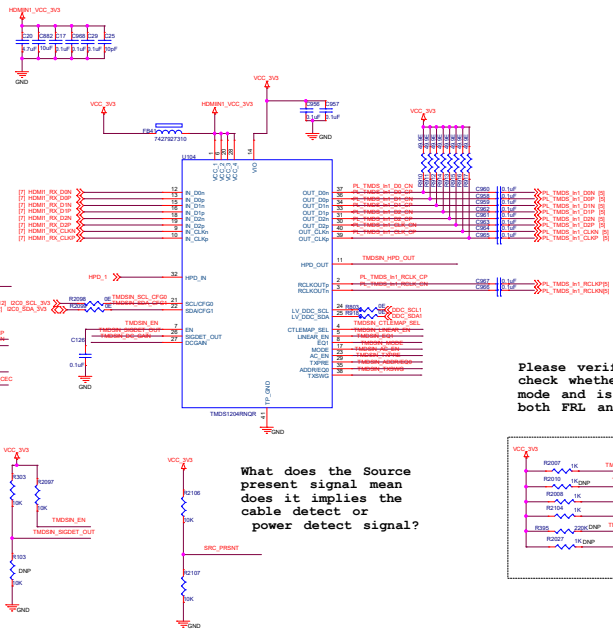
Does the pull up is enough for DDC scl and sda ? is 2k enough? this is DNP since the level translator has internal pull up

Why is not HPD is taken from FPGA? In previous TMD5 IC the HPD was taken from FPGA and given to the sink and then from HPD source will be given to connector

What is the purpose of SIGDET. Why is the output given to FPGA?

What does the Source present signal mean does it implies the cable detect or power detect signal?

Please verify the Pin strapping check whether it is in Pin strap mode and is whether configured for both FRL and TMD5 transmission

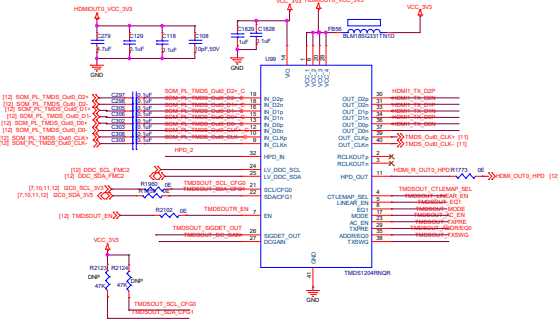
Please verify this for the Source side application
